## GFA AIRWORTHINESS DIRECTIVE

**TYPE AFFECTED:** Discus 2b, serial numbers 1 to 133.

**SUBJECT:** CG (belly) release, installation position.

SCHEMPP-HIRTH Flugzeugbau GmbH. Kirchheim/Teck	Technical Note No. 349 - 26 No. 360 - 18	Page No: 01 No of pages.: 02
--	--	---------------------------------

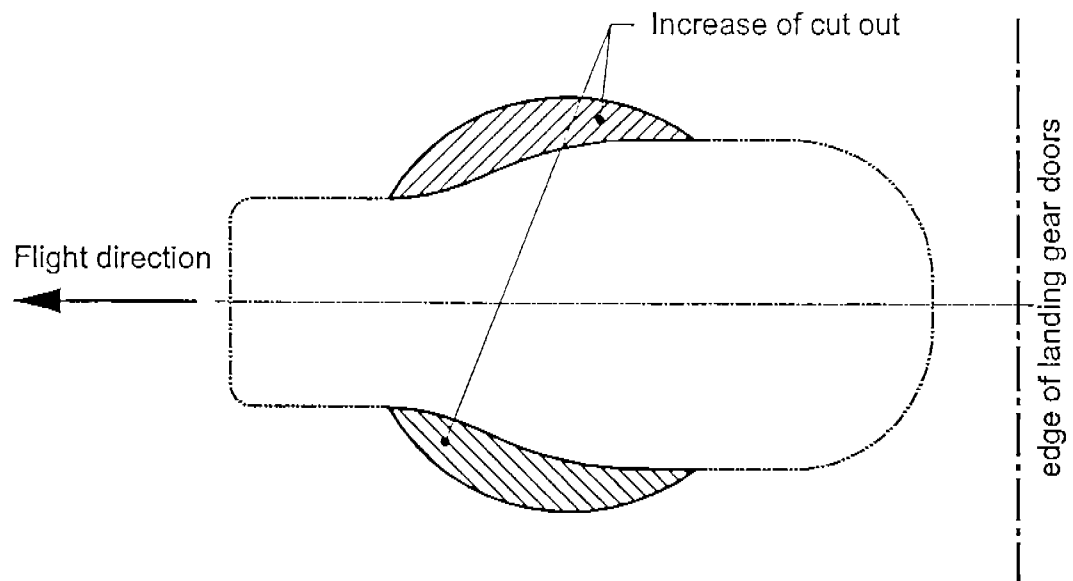
1. Remove seat pan
2. Remove release cover
3. Remove cable connection to release
4. Release attachment
  - a) Loosen aft screw (number 5)
  - b) Remove forward screw. Rotate release upwards and attach release again in the lowest hole (number 4)

- c) Tighten again aft screw (number 5)
5. Attach cable connection with the additional fittings, see photo page 03.
6. Increase the cut out in the fuselage bottom for the release with the aid of the templates, see page 02.  
The cut out should be increased so far that with the cable ring engaged and pulled forward the pair of cable rings support against the automatic release device.

EXTRACTED FROM DRAWING  
NO. S08 RB 850

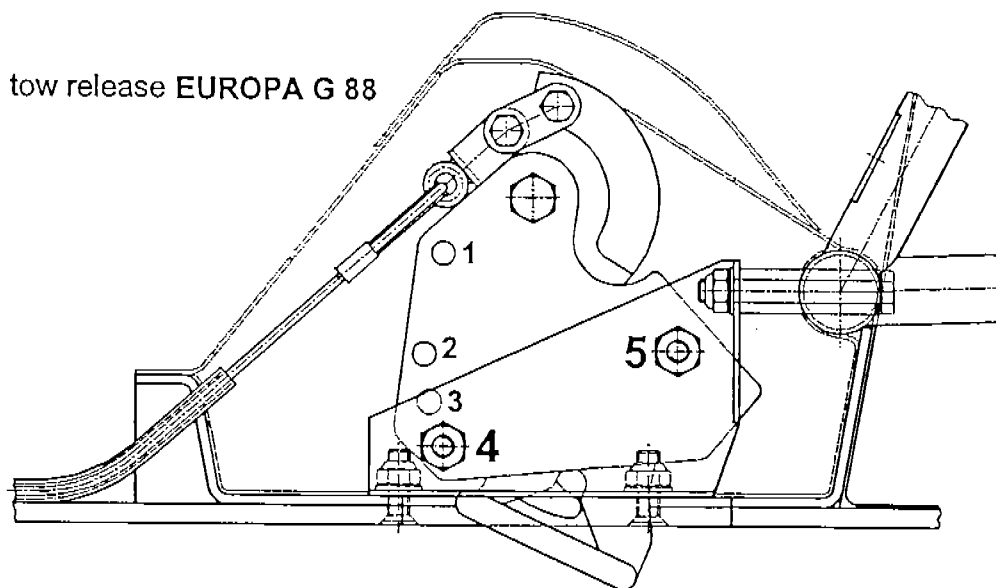
to be attached by bolts No. **4** and **5**

EXTRACTED FROM DRAWING  
NO. S11 RB 842

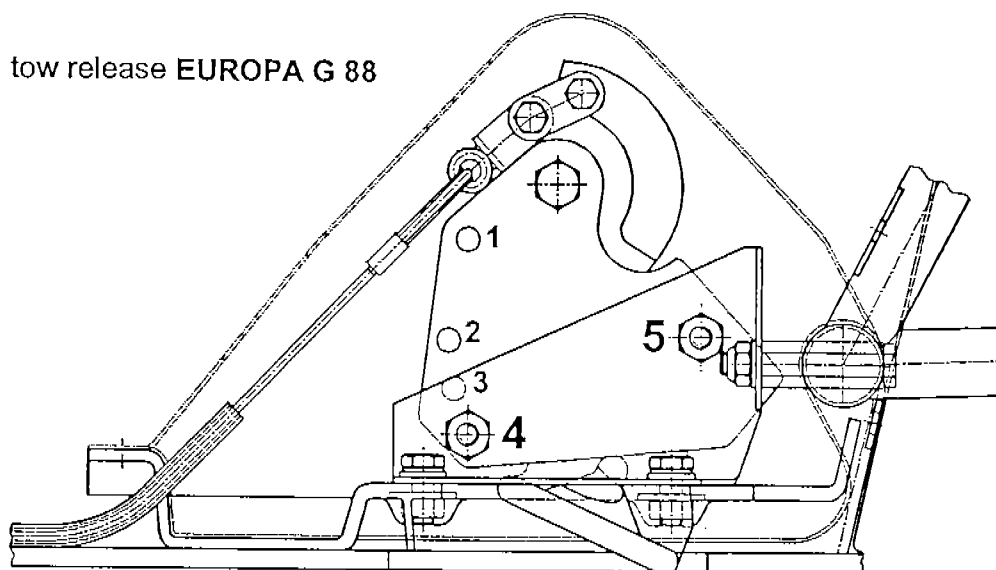
to be attached by bolts No. **4** and **5**
